ADDENDUM

PROJECT NAME: CENTRAL YORK FIREHALL

PROJECT NO.: 25274.001.E.001

ADDENDUM No.: 01

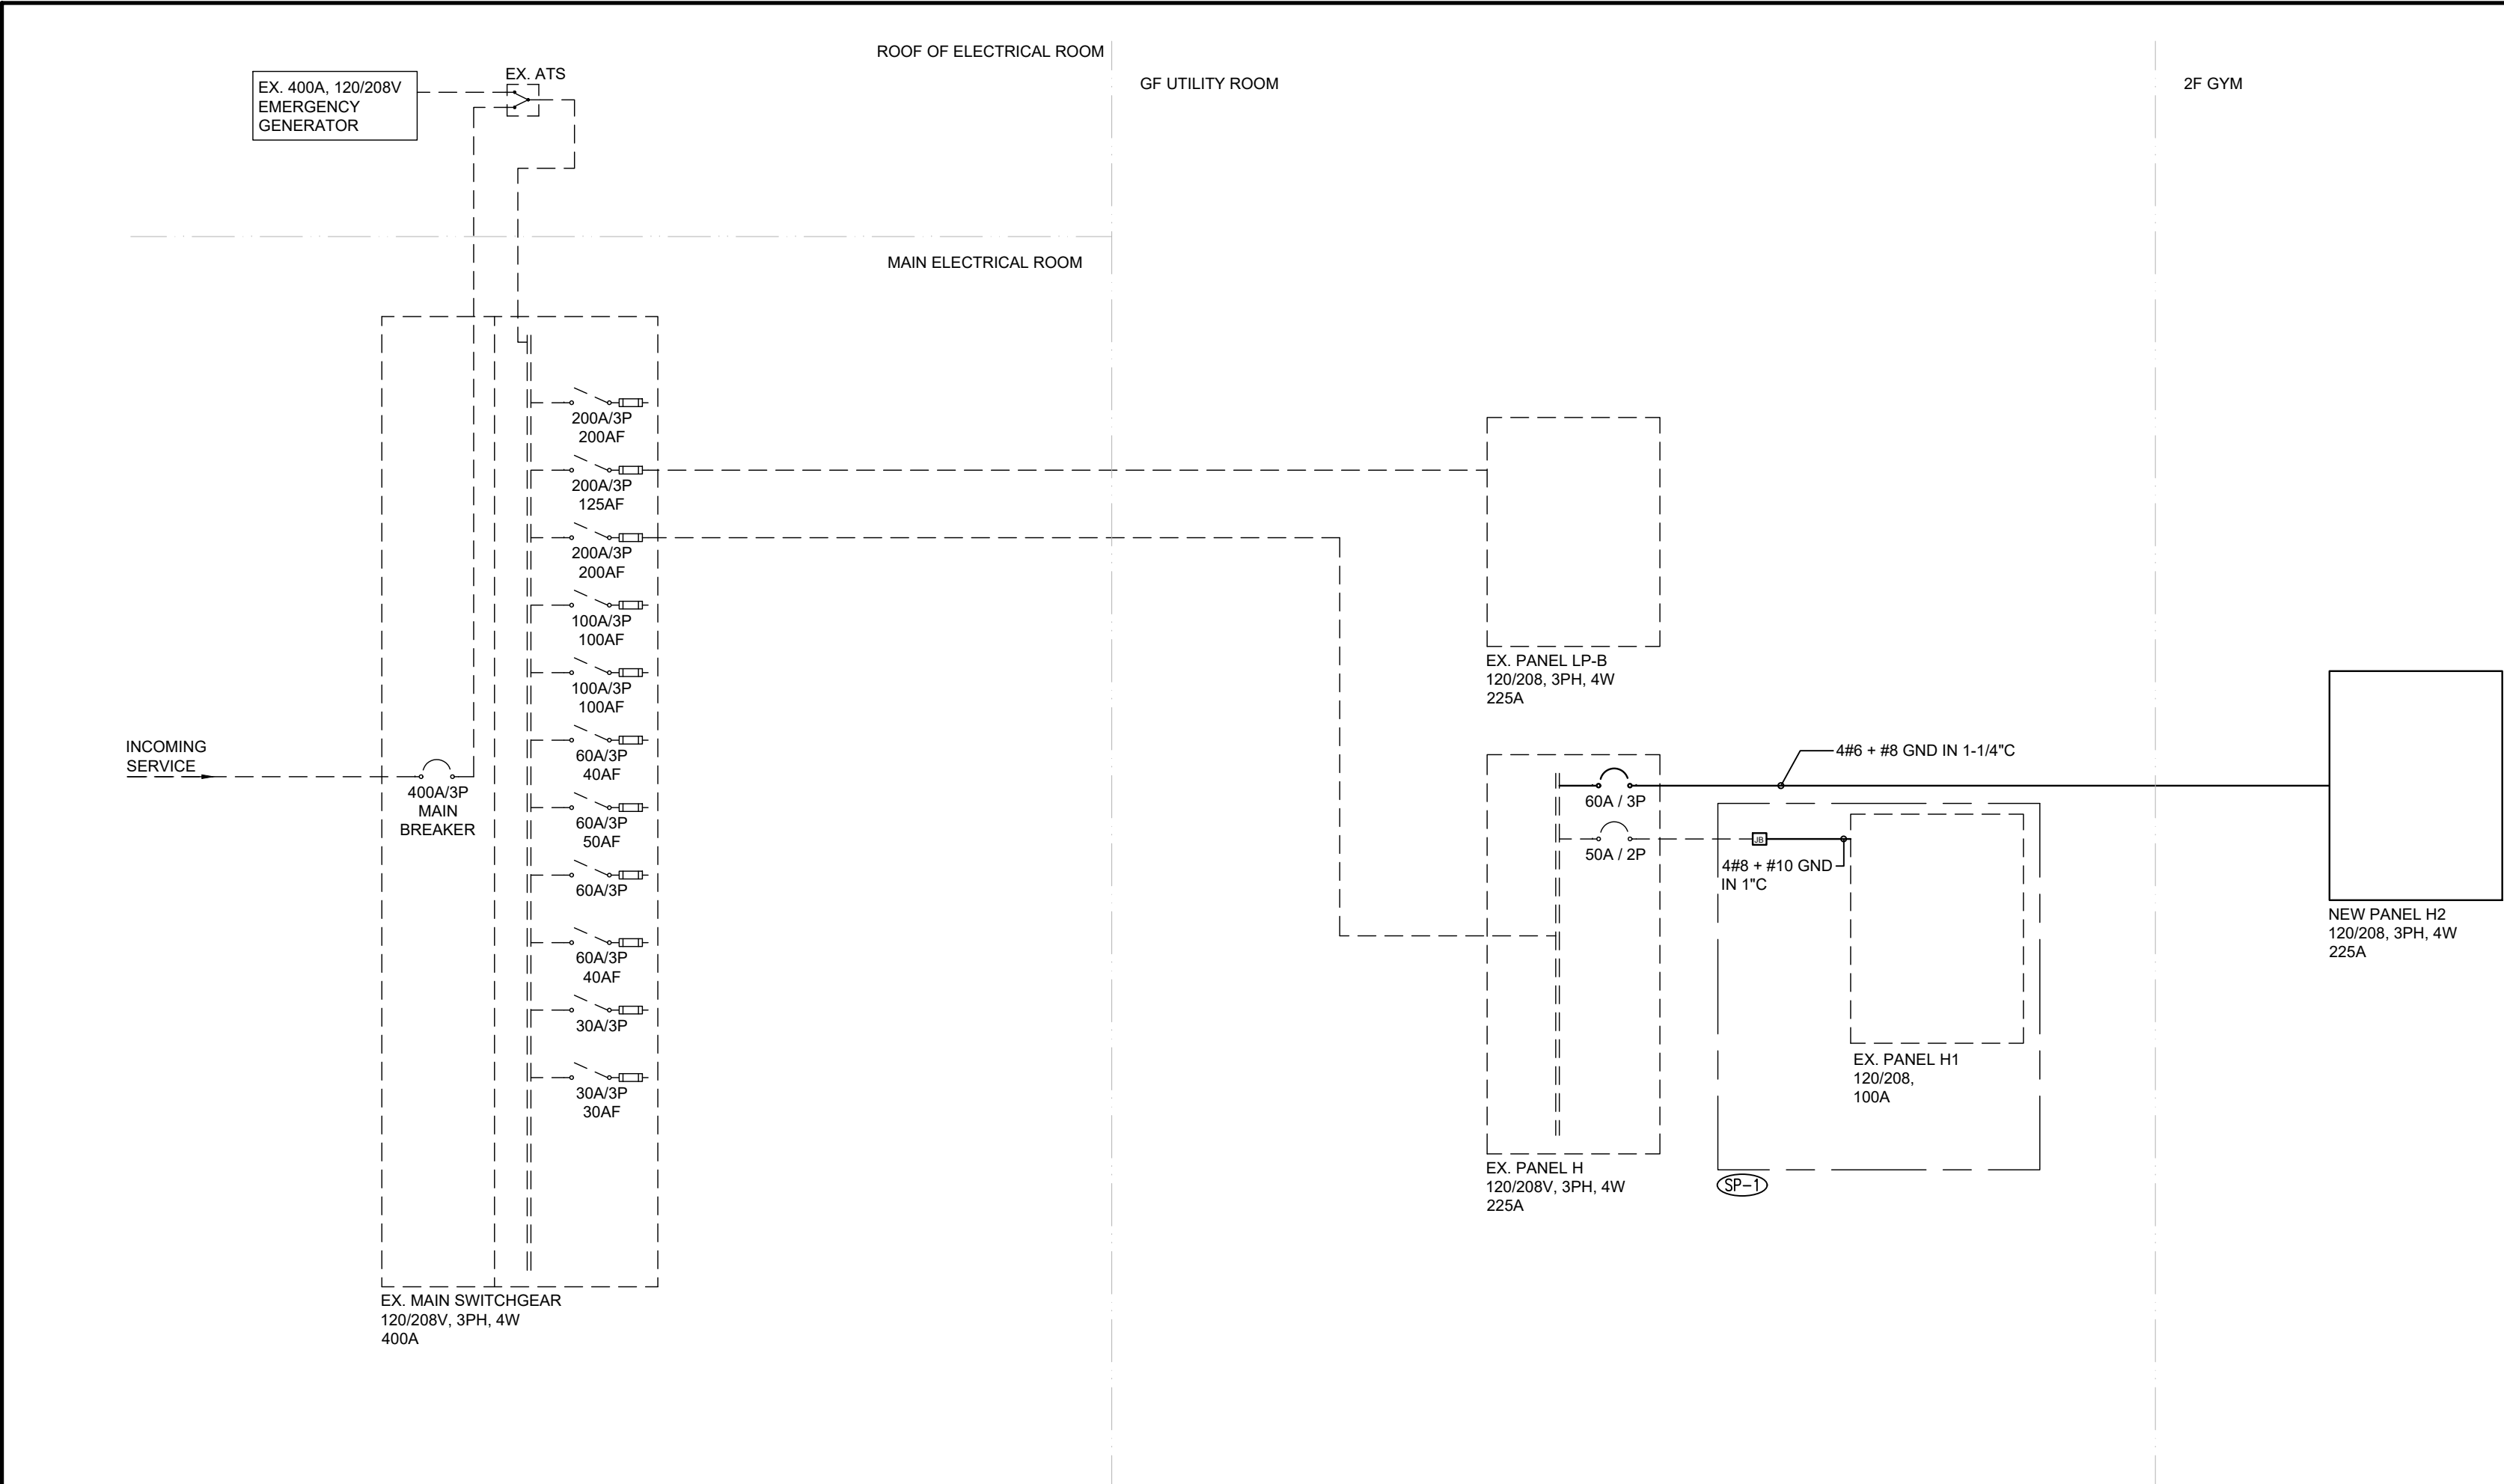
1.1 Refer to TE-0.3 - ELECTRICAL DETAILS (included herein)

1.1.1 Revise panel schedule.
